Conservation Commission Meeting

Subject: Request to Extend Existing Order of Conditions
Order of Conditions (DEP File No, 321-0169)
551 Rear Arsenal Street, Arsenal Park Phase A Improvements

Re: 57 Coolidge Ave – DEP 321-0175 WWO-2021-02 (the "Project")
Bio-retention detail revision

Regarding: 10-30 Manley Way
DEP file No. 321-0188
Response to Conservation Commission Comments

DEMOLITION AND EROSION CONTROL PLAN
DRAWING NUMBER:
C-1B
PROJECT NUMBER:
21049
Copyright © 2022 by R.J. O'Connell & Associates, Inc.

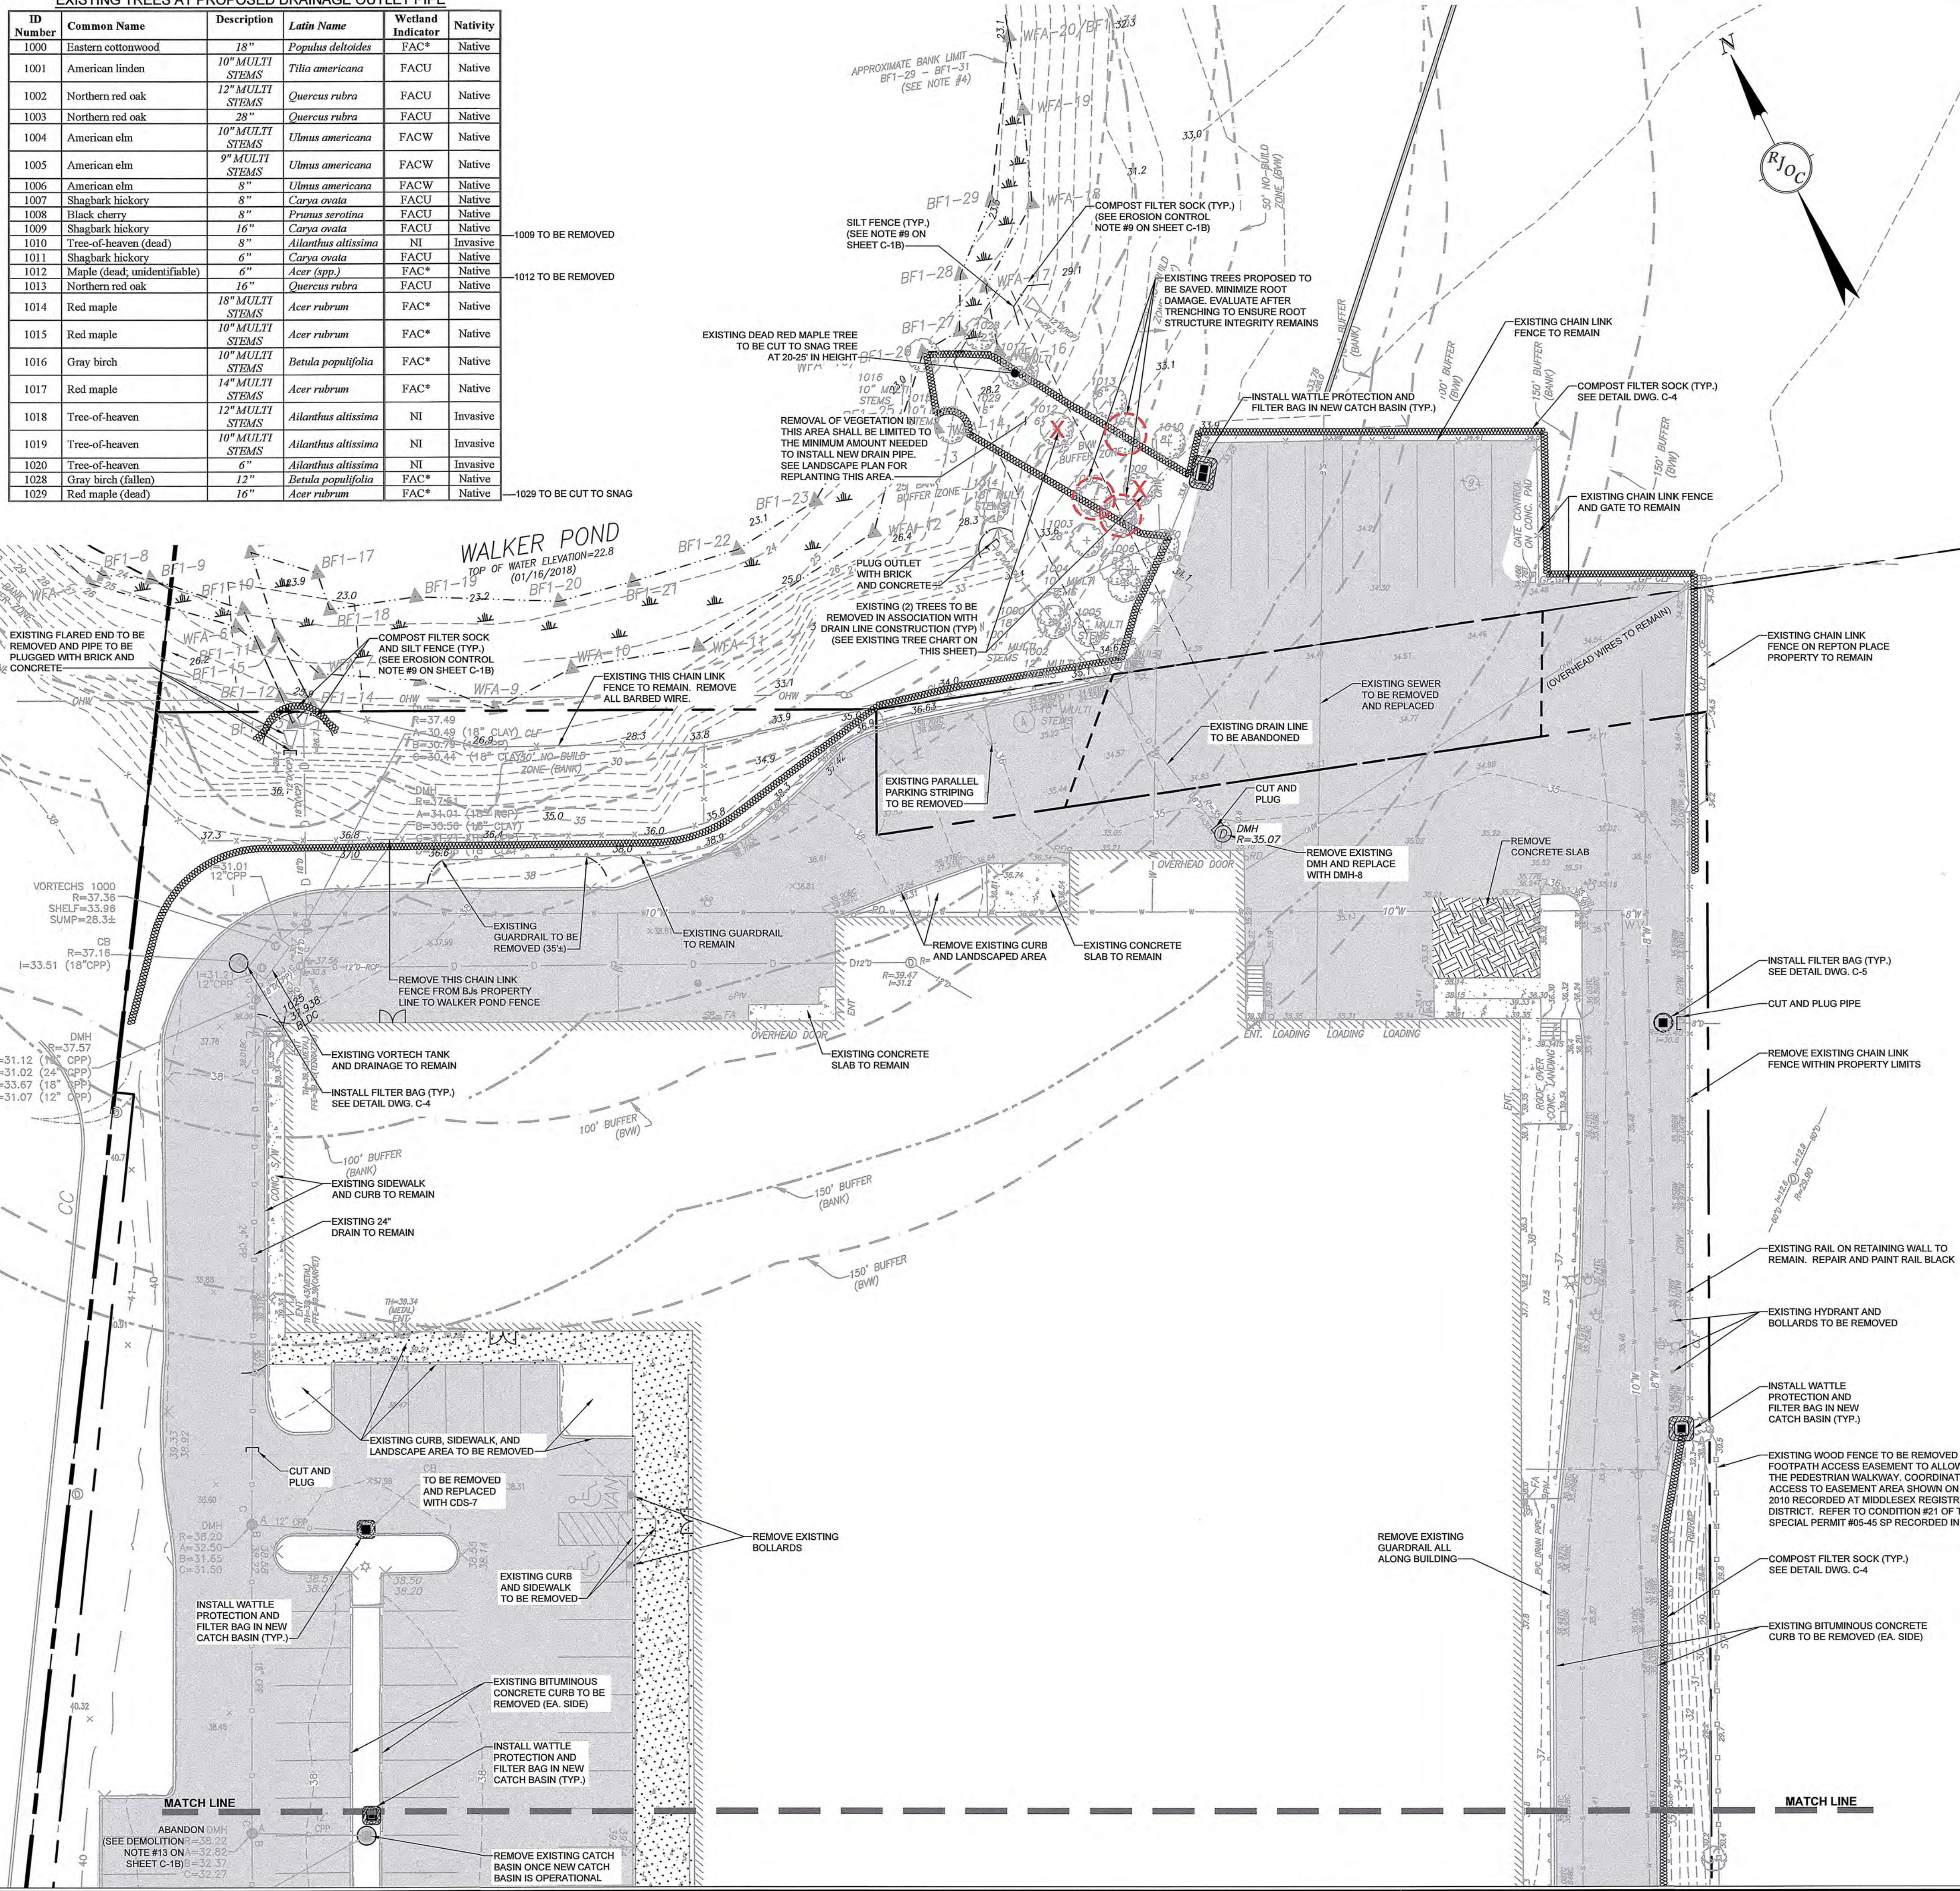
- **RJOC has received the memorandum from the Watertown Forestry Supervisor/Tree Warden, see Attachment C, requesting that the proposed drain pipe to the pond be relocated to reduce the number of trees proposed to be removed. The drain outlet line has been revised accordingly, as depicted on revised Sheet C-2B, which results in the removal of three (3) trees, as depicted on revised Sheet C-1B. Of the three (3) trees to be removed, two (2) are currently dead, therefore only one (1) healthy tree is now proposed to be removed with a DBH of 16". There is one (1) additional dead Red Maple in close proximity to the proposed work that has been noted on Sheet C-1B to be cut down to a snag tree of 20-25' in height. Sheet L-4, Landscape Plan, has been revised to show the relocated drain pipe and re-planting with New England Conservation Wildlife Mix over the pipe.**

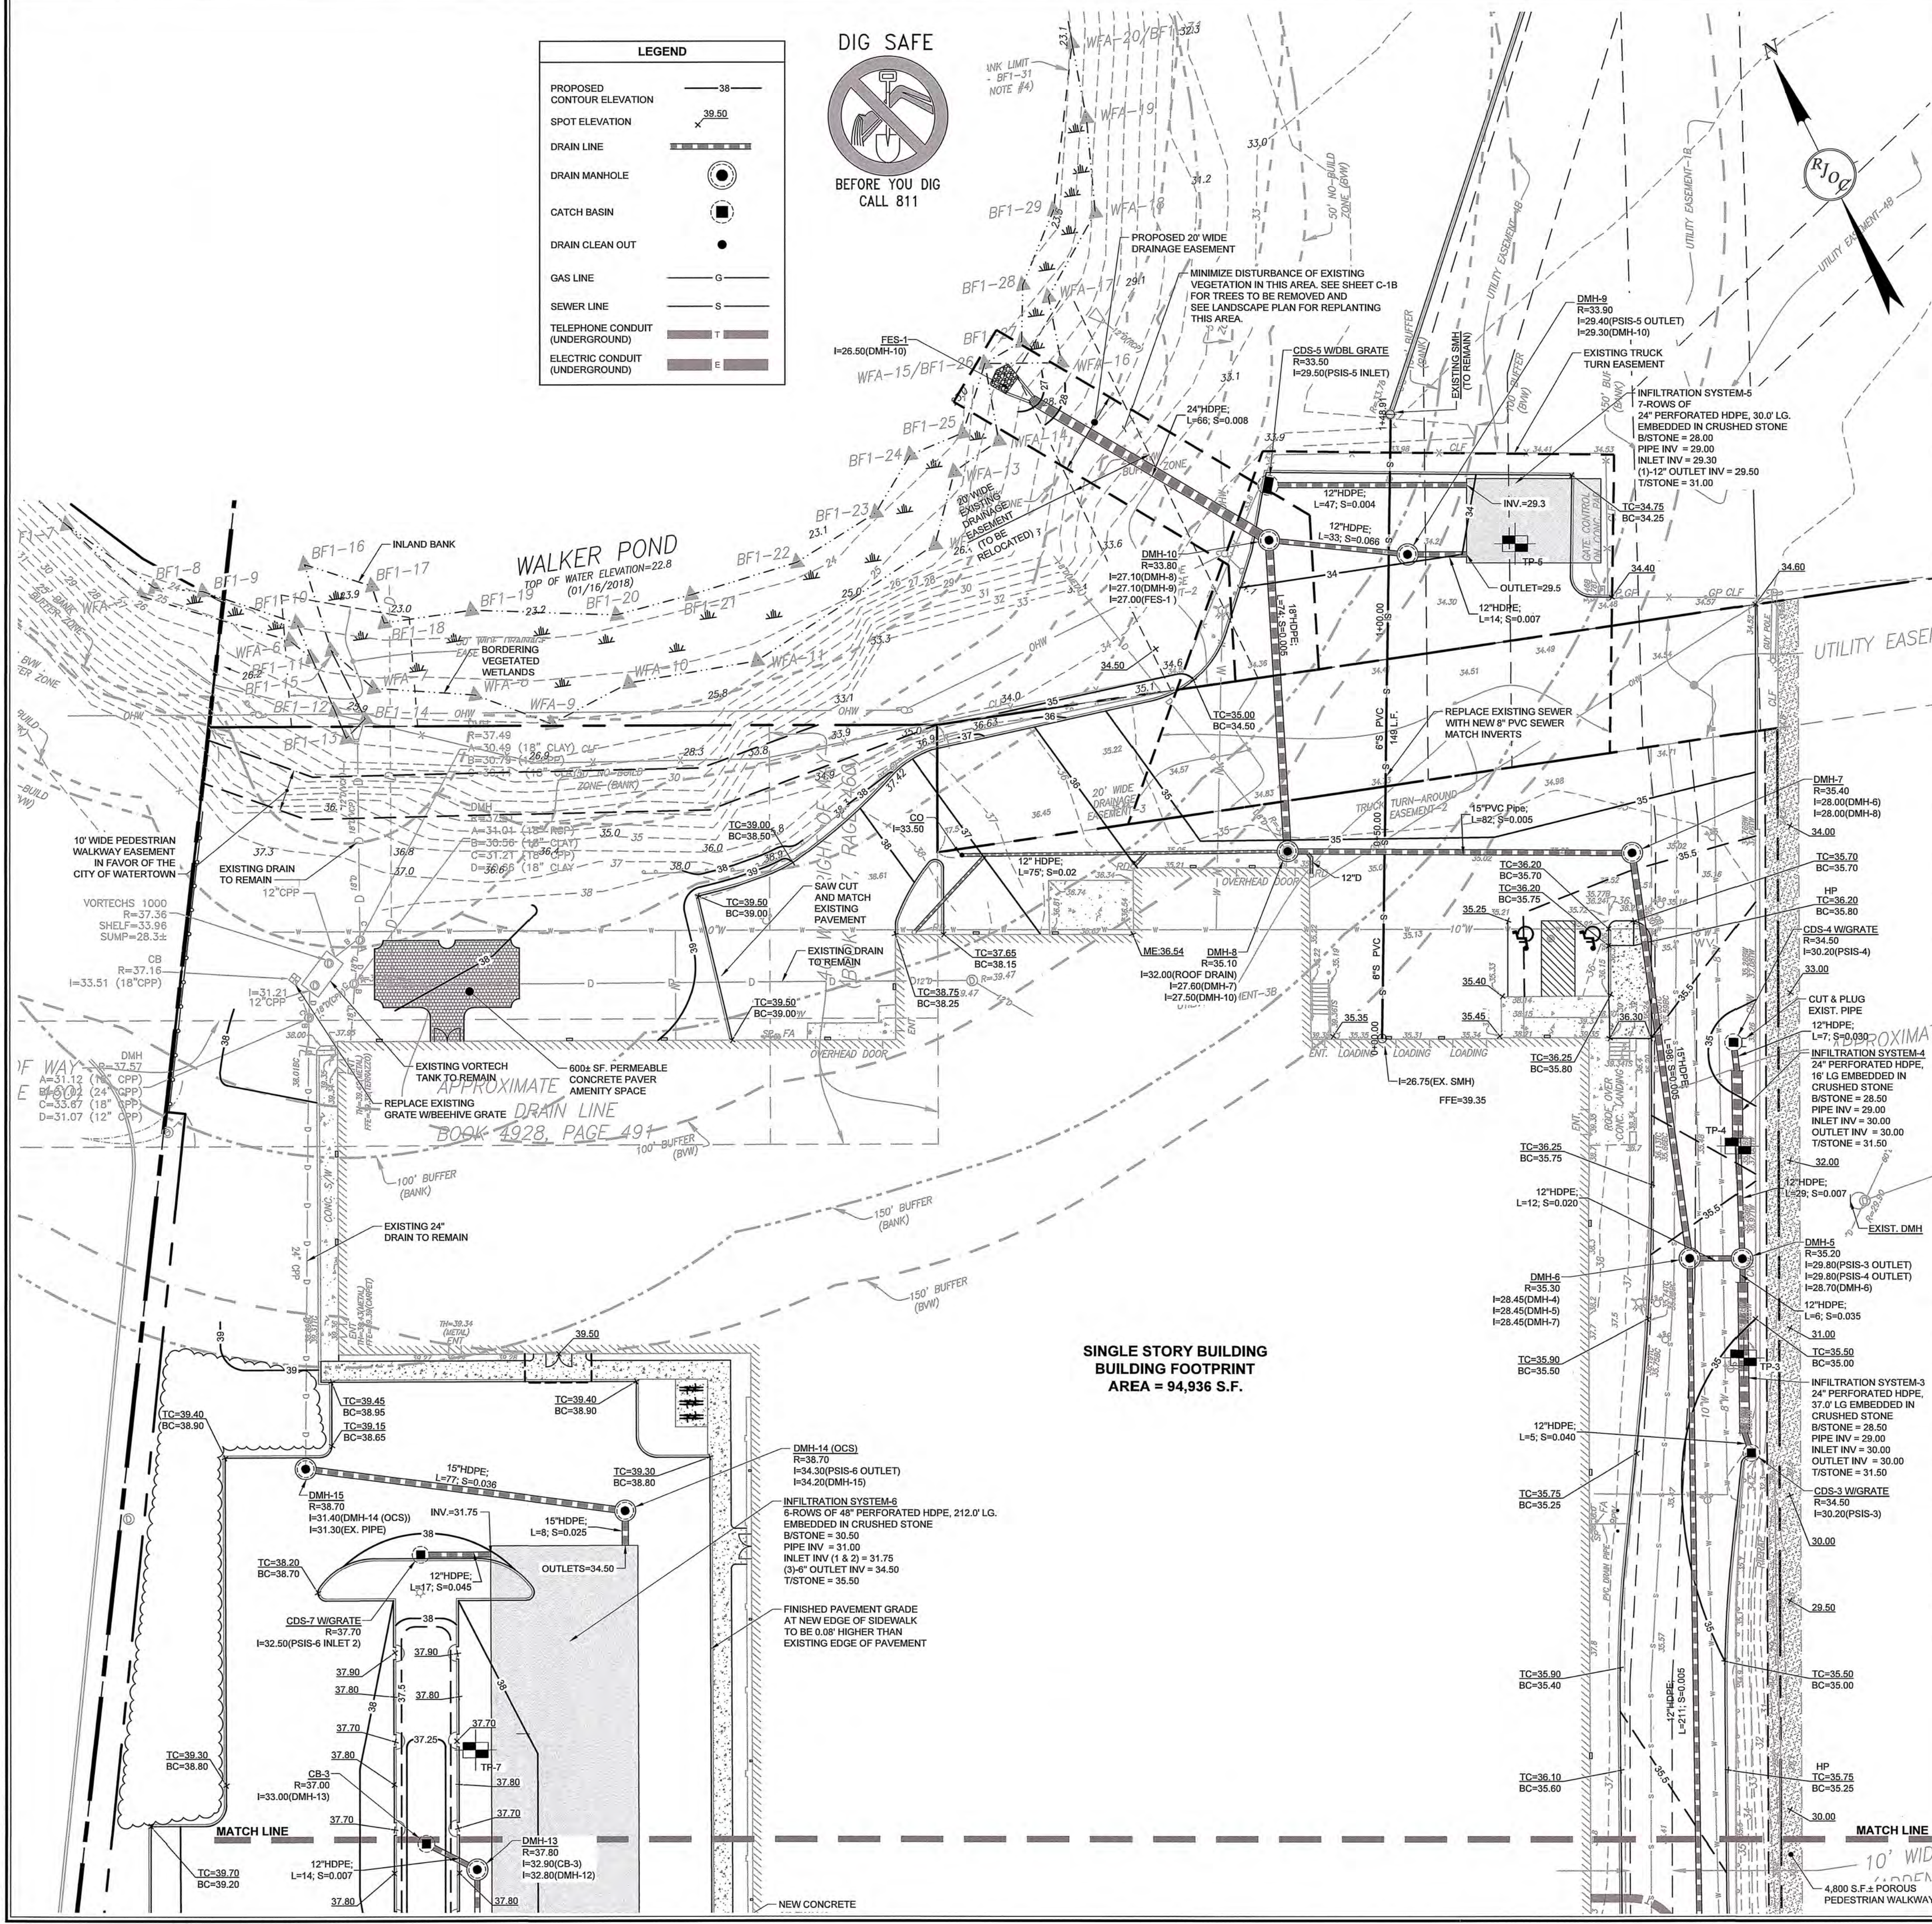
2. *Initial comment: Review Easement Agreement for the Truck Turnaround Area and confirm if it allows below ground utilities and/or drainage system.*

Addition information request: Provide written documentation from City that they will approve a new or amend easement for subsurface infiltration system; Redesign subsurface infiltration system to be outside of 100' buffer zone and relocate drain manhole further away from wetlands.

- **Subsurface Infiltration System-5 has been relocated so the footprint of the system is fully outside of the 100' Wetland buffer. See revised Drawing Sheet C-2B for system relocation and revised Drawing Sheet C-6 for redesigned system layout. As a result of the system redesign, DMH-10 has been relocated into the paved area and outside of the vegetation.**
3. *Initial comment: What is the impact to the existing trees in the area where the new drain pipe will be installed at Walker Pond to replace the existing deteriorated pipe. Any trees over 6 inches in diameter need to be located and shown on the plan or in a sketch.*
